HILLS ENGINEERING CONSULTANTS PTY LTD

Project location: No.1-7, Anderson Rd Liverpool, NSW

project name / subject: **Memorandum – South Elevation Scaffold Affected by Trenching Works**

①

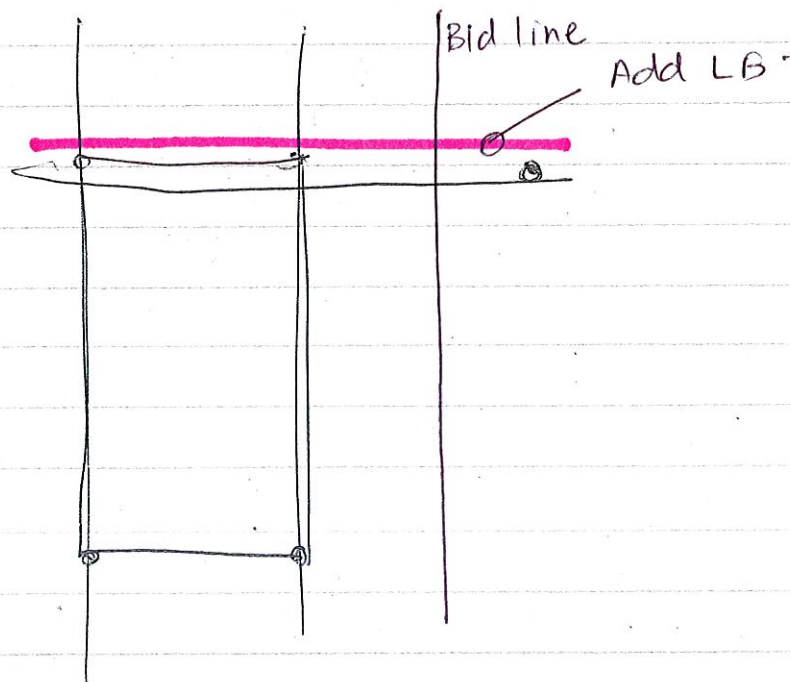
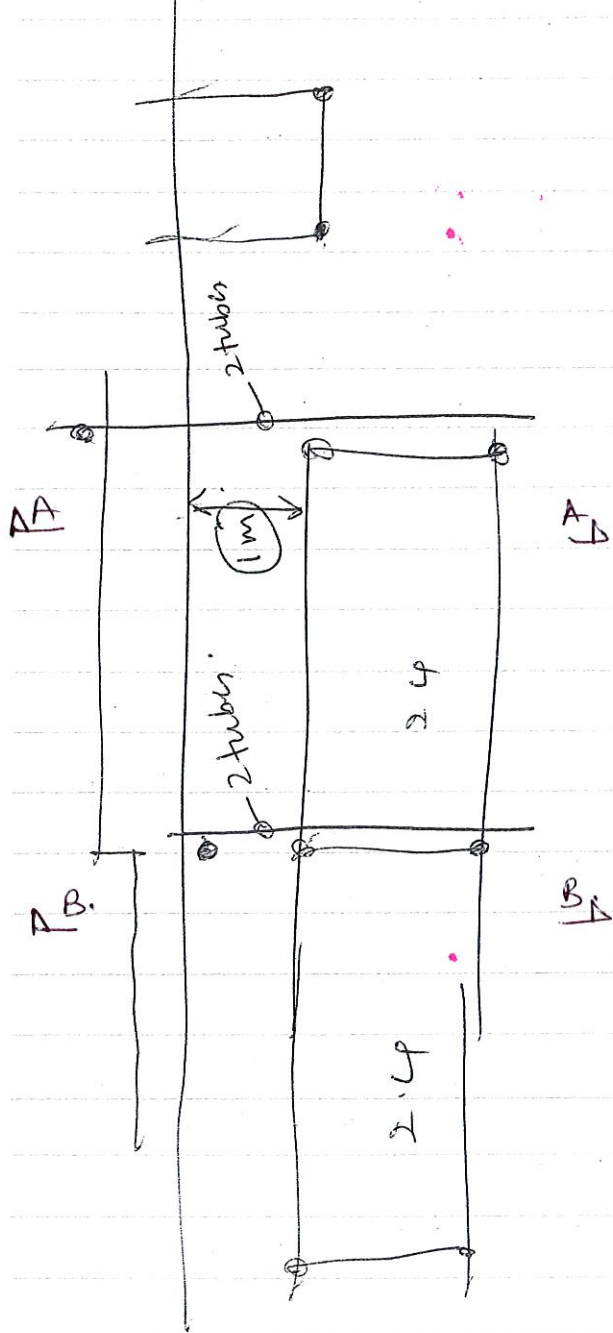
At the time of inspection, the Scaffold was found to be undermined by plumbing excavations for plumbing works at 5 locations along south elevation. Sketches for rectification works and location photos are attached at the end of this report for action by FSS and Principal Contractor.

(2)

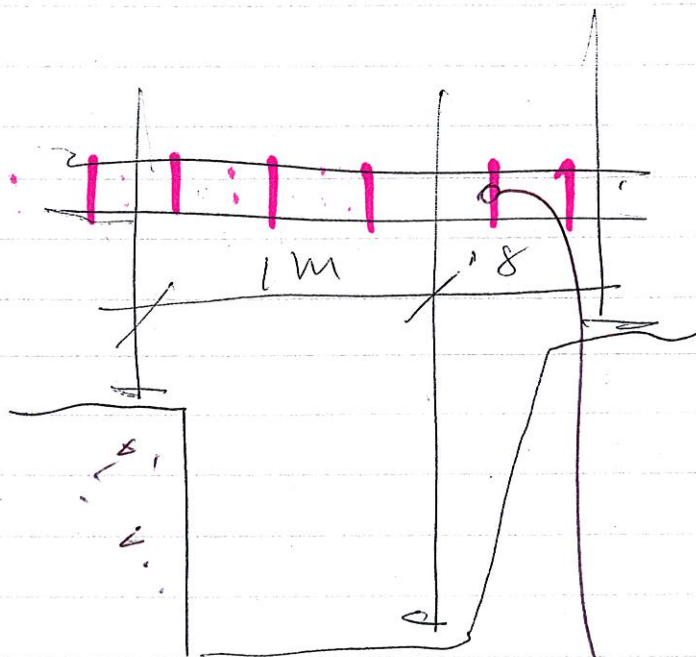
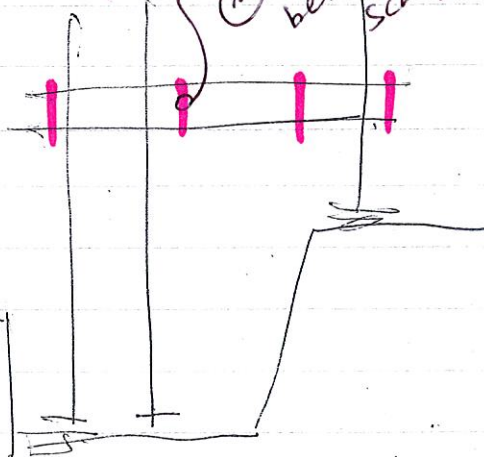
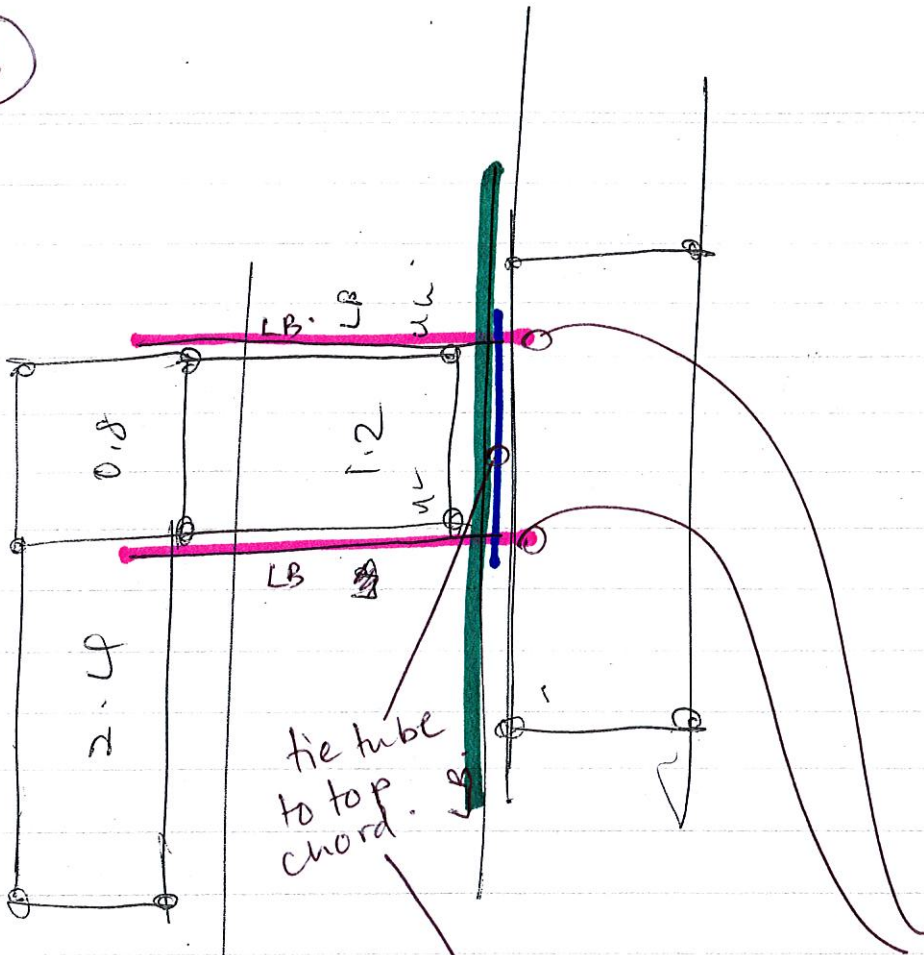
Add 600 long
scat tubes + DCS
300 c/c as rungs
between two
scaffold tubes

3

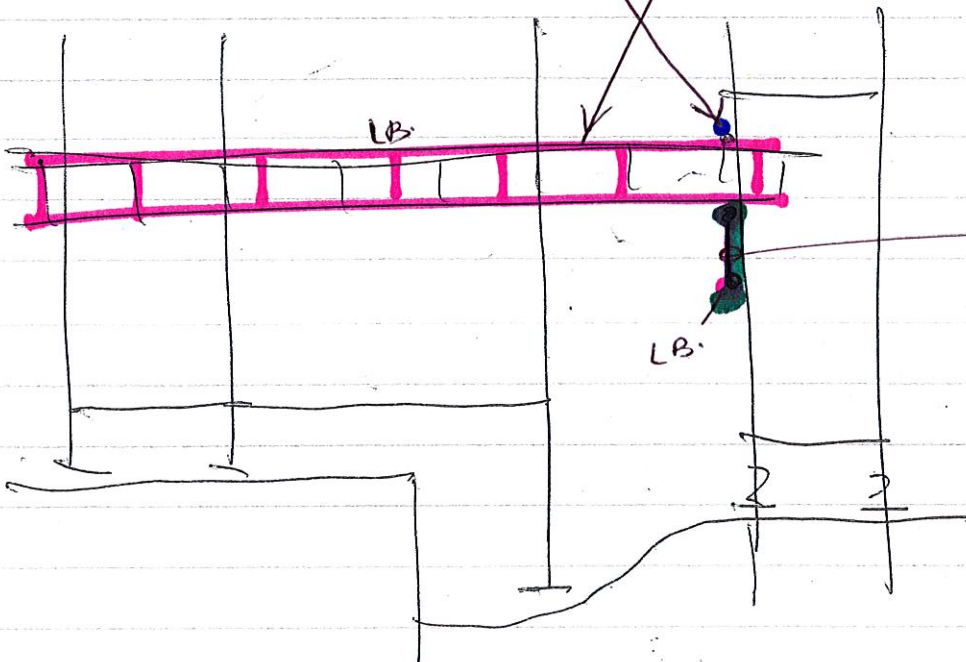
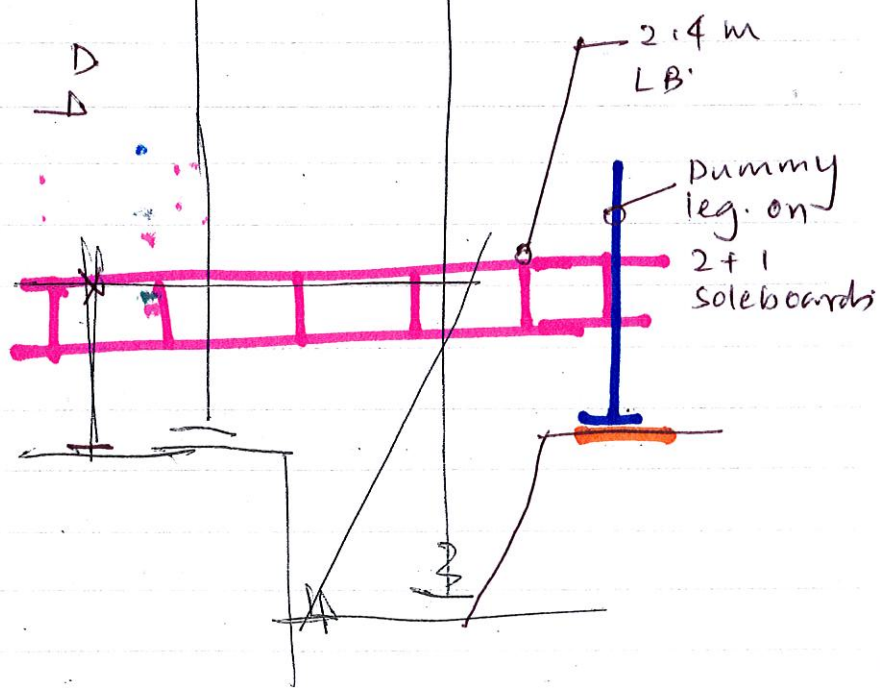
Add two LB.

cross Ladder
beam
